ASBUILT DRAWING

CONSTRUCTION PLANS
SMOKEY POINT DISTRIBUTING, INC.
BUILDING PERMIT
UTILITIES AND PROFILES

JOB NO. 1406C
4
5

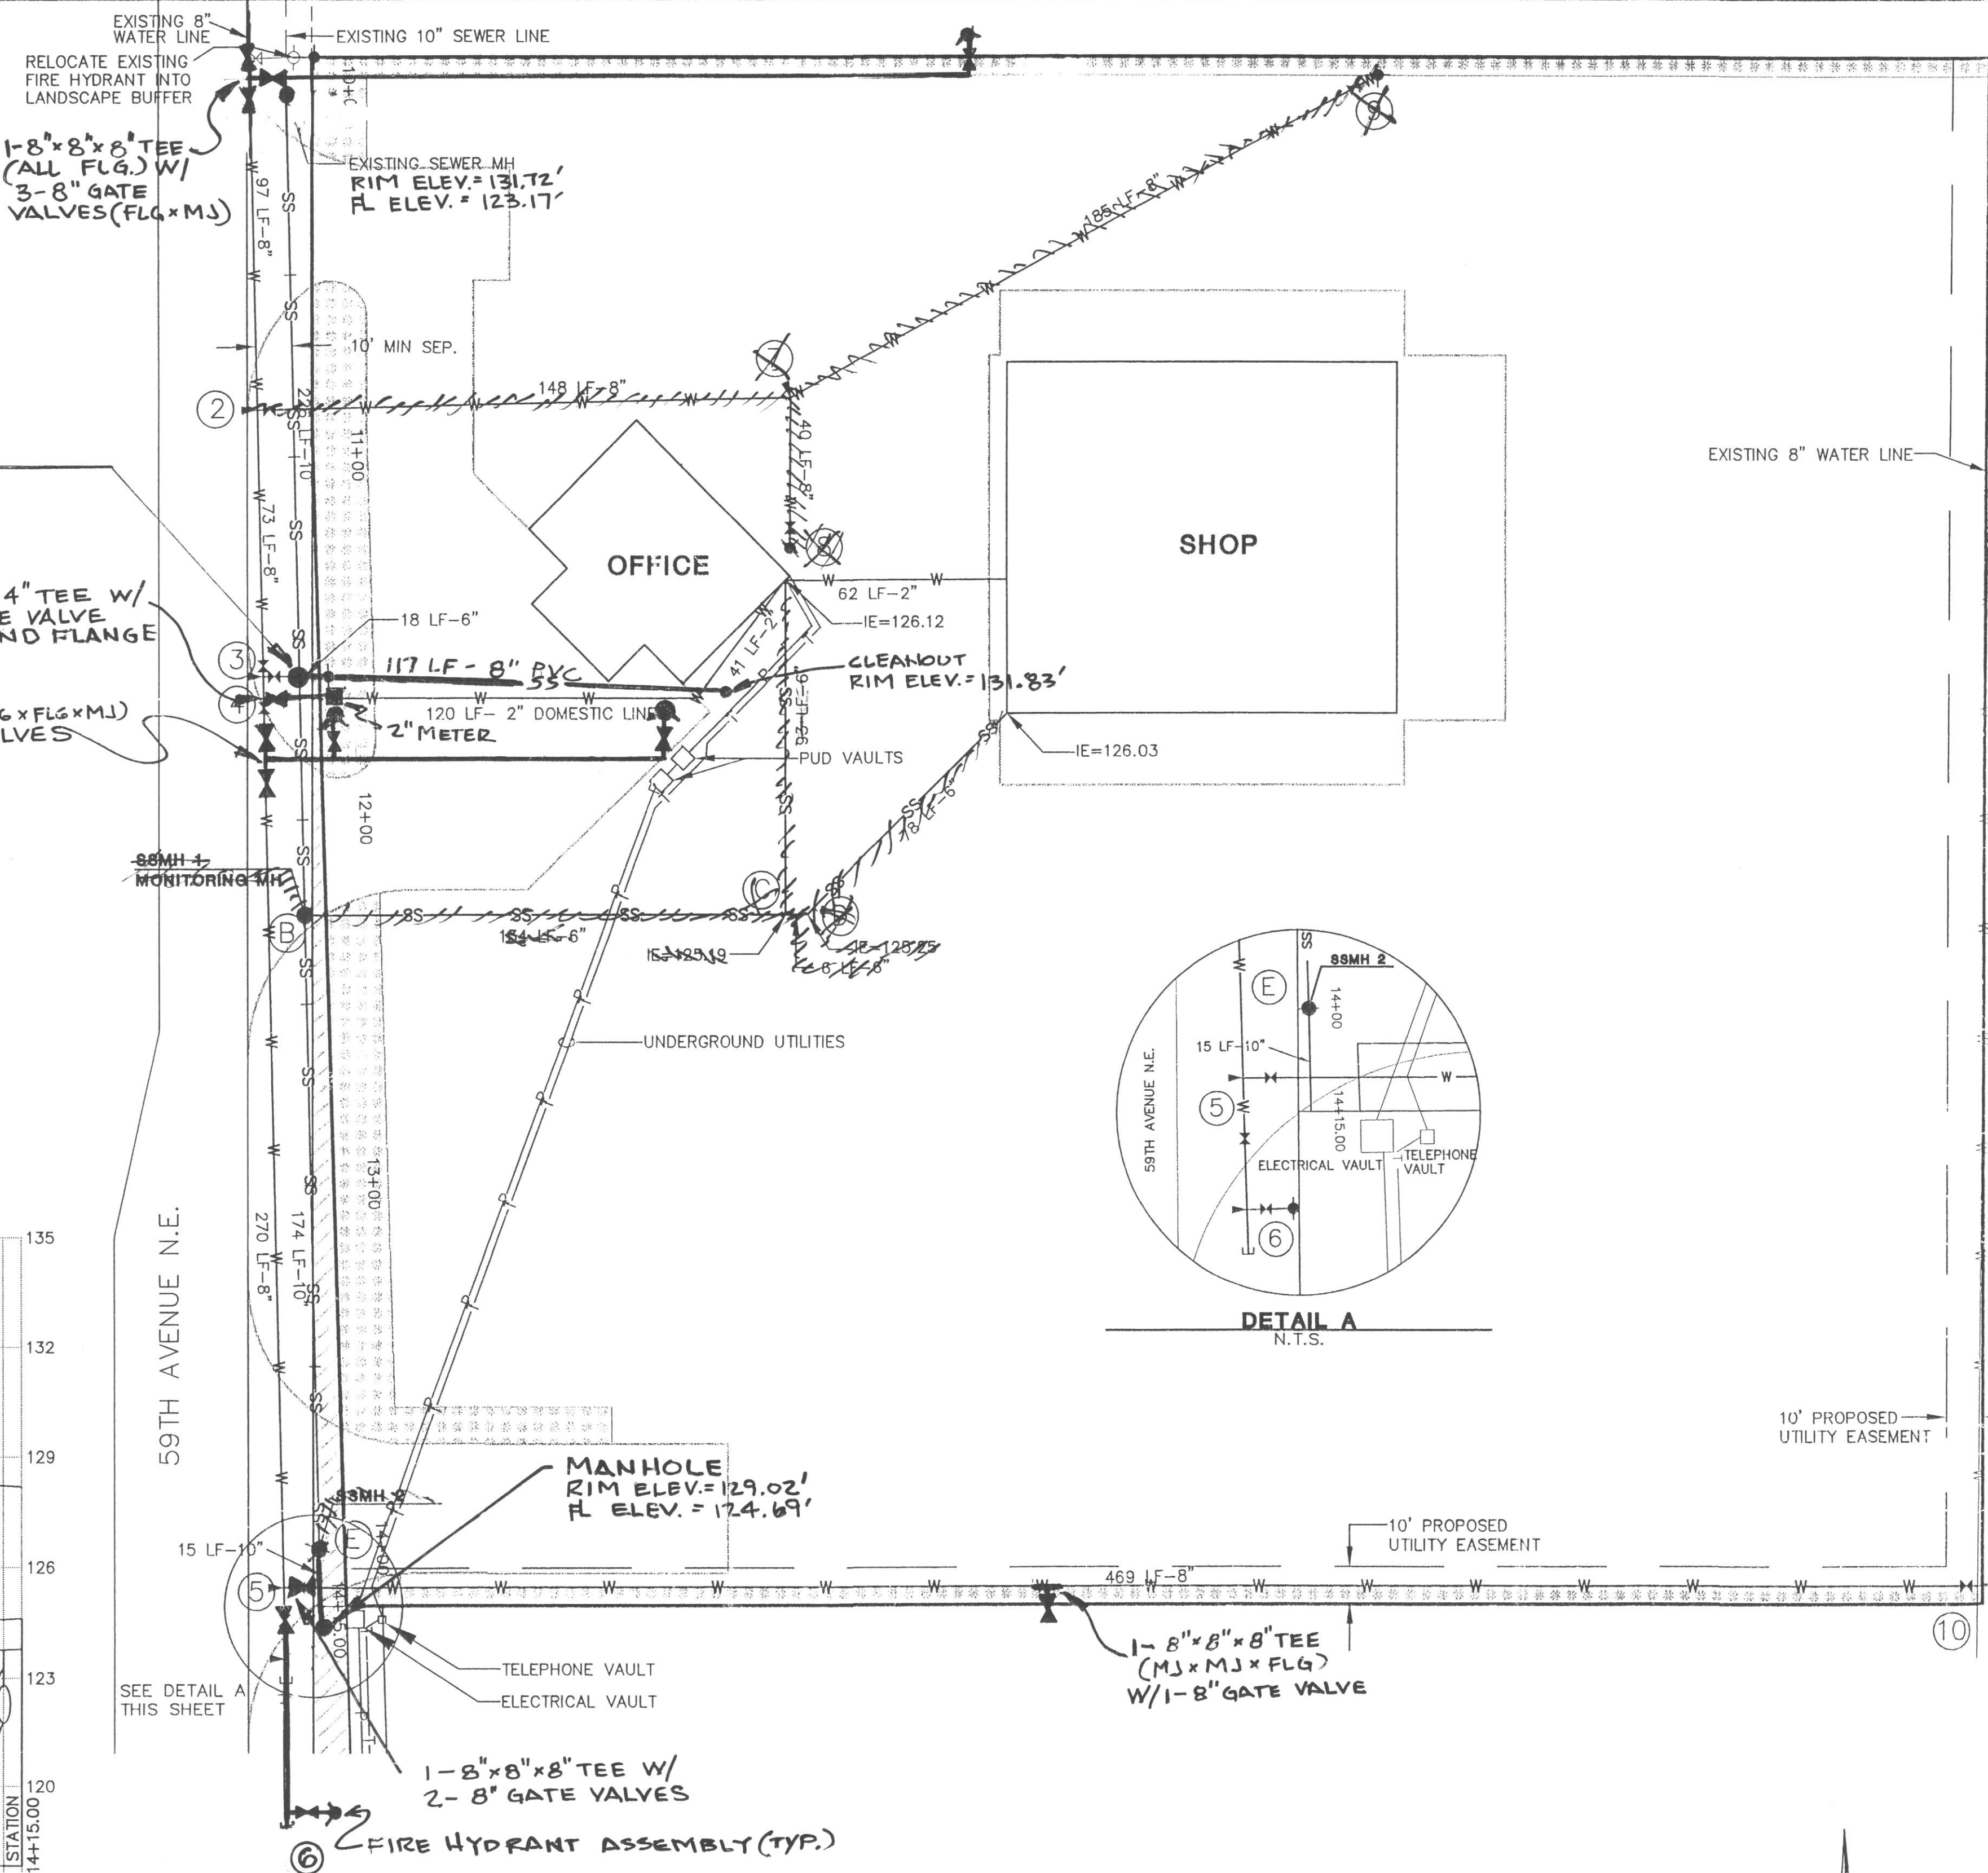
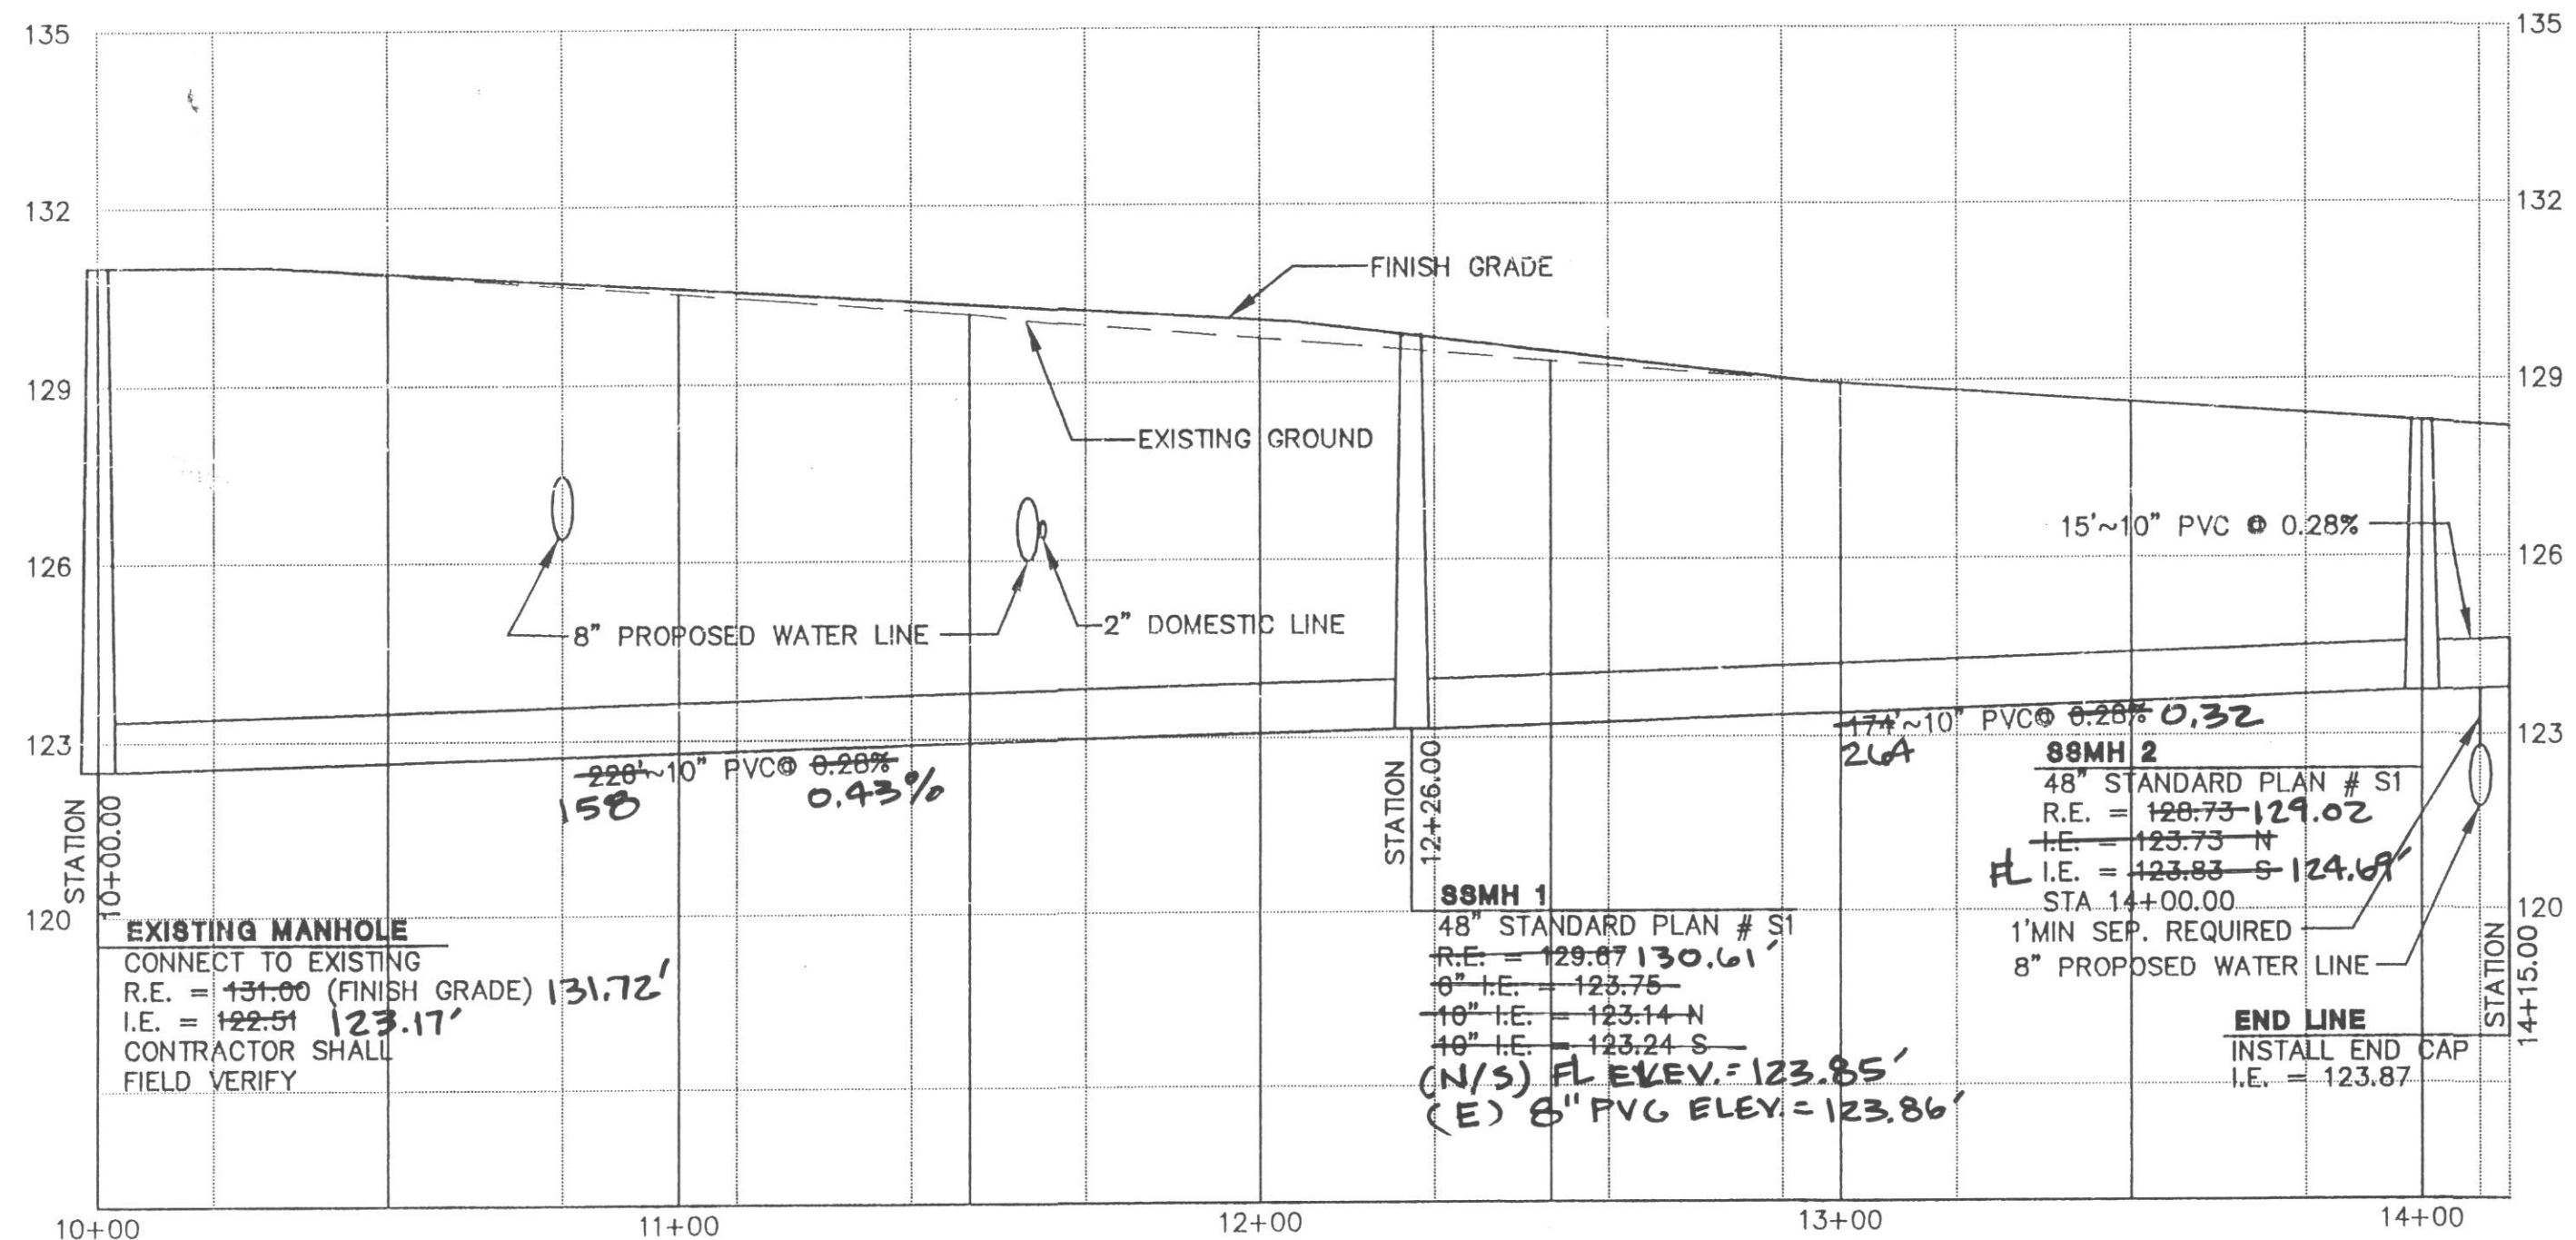
- ~~CONNECT TO EXISTING 8" WATER LINE AS SPECIFIED IN CITY OF ARLINGTON PWCS. INSTALL 8" GATE VALVE.~~
- ~~INSTALL 8" GATE VALVE, 8"x8"x4" TEE, 4" GATE VALVE, 4" BY 2" REDUCER, 2" DOMESTIC CONNECTION AND DCVA AS SHOWN AND BLOCKING, SEE STANDARD PLAN NUMBER W3, W10, W13 (PWCS).~~

- ~~INSTALL 8" GATE VALVE, 8"x8"x6" TEE, FIRE HYDRANT ASSEMBLY AND ONE SECTION OF PIPE AS SHOWN. SEE STANDARD PLAN NUMBER W1.~~
- ~~INSTALL 8"x8"x8" TEE AND TWO 8" GATE VALVES, BENDS AS REQUIRED AND BLOCKING AS SHOWN. SEE STANDARD PLAN NUMBER W3 FOR BLOCKING.~~

- INSTALL 8"x8"x8" TEE, FIRE HYDRANT ASSEMBLY, BLOCKING AND END CAP AS SHOWN, SEE STANDARD PLAN NUMBERS W1, W3
- INSTALL 8"x8"x8" TEE AND BENDS AS REQUIRED WITH BLOCKING. SEE STANDARD PLAN NUMBER W3

- INSTALL FIRE HYDRANT ASSEMBLY. SEE STANDARD PLAN NUMBER W1
- INSTALL FIRE HYDRANT ASSEMBLY. SEE STANDARD PLAN NUMBER W1
- CONNECT TO EXISTING LINE PER CITY OF ARLINGTON PWCS. INSTALL 8" GATE VALVE, 8" TEE THAT WAS CUT IN WITH 1-8" GATE VALVE ON THE WEST LEG. 2- COMPRESSION COUPLINGS W/ 2 STUBS OF PIPE.
